TB09-157R

TECHNICAL SERVICES BULLETIN

Re: Check Valve Assembly Installed Incorrectly in B4VM-E, PAH2VM-E**
and C6BH-I** Coils.**

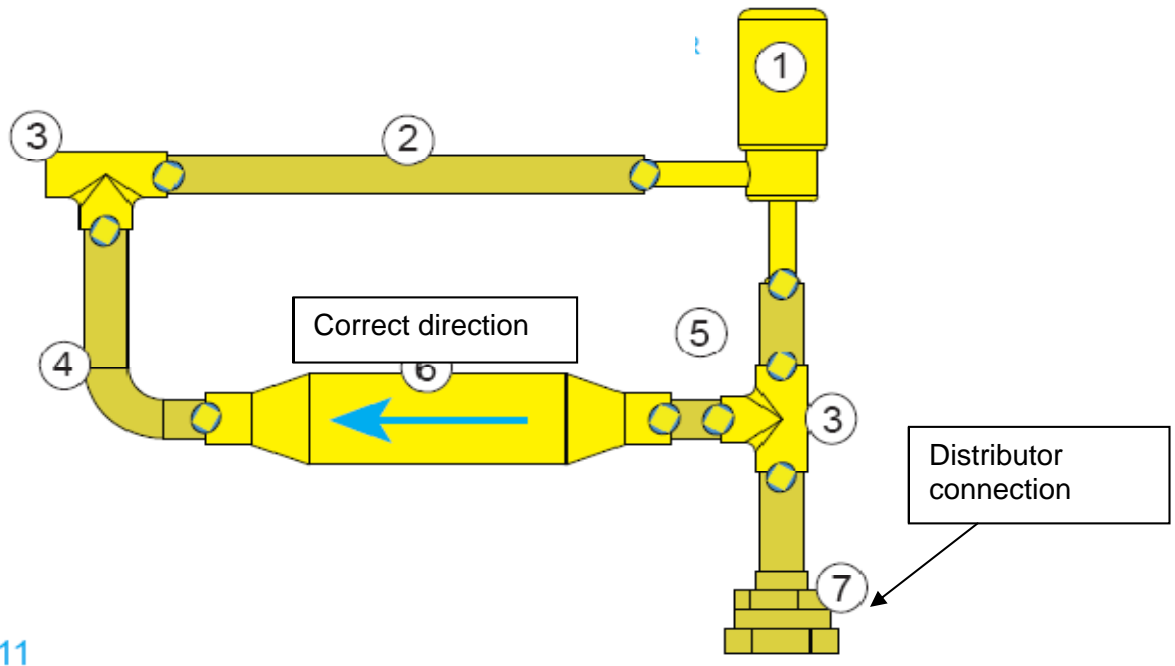
11
 The correct arrow direction should be pointing away from the distributor connection

Incorrect direction, do not install. Arrow is stamped on the check valve assembly

If you have one installed incorrectly in the field you would see higher than normal Suction pressure in the cooling mode in both the iQ Heat Pump and iQ Air Conditioner systems. If this is the case replace the coil under warranty.
